Interactive comment on “A new borehole electromagnetic receiver developed for CSEM methods” by Sixuan Song et al.

Sixuan Song et al.

Received and published: 21 June 2020

Fig. 1.

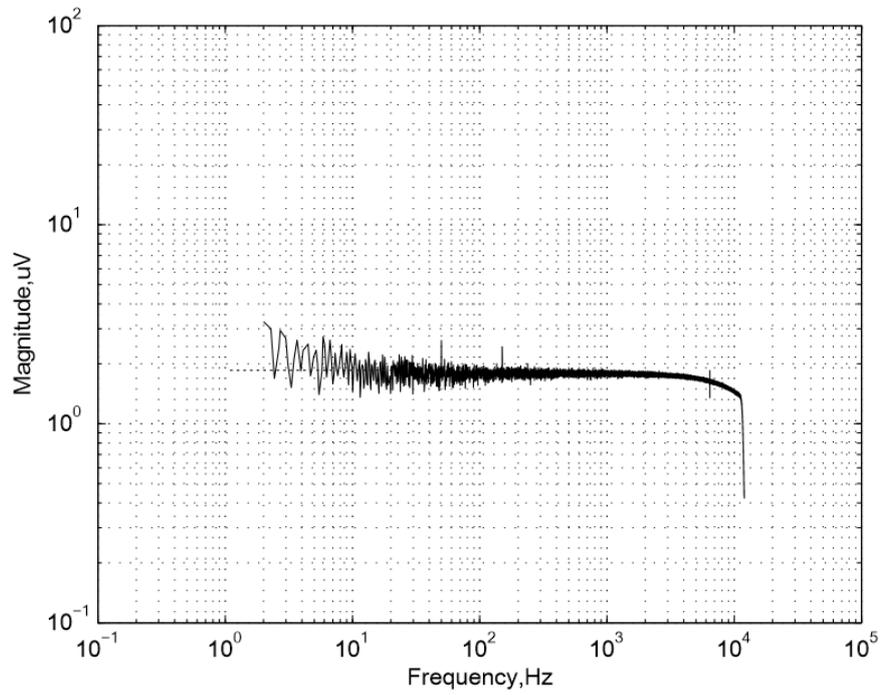
5) Figure 8 is not clear and should be redone.

Response: Thank you for your comment. As advised, we have revised Figure 8 to read as follows.

Figure 9: Field layout of the experiment. (p. 10, lines 239-240) BH1 and BH2 are placed at a certain depth in the borehole. The transmitter and the electrodes are on the ground.
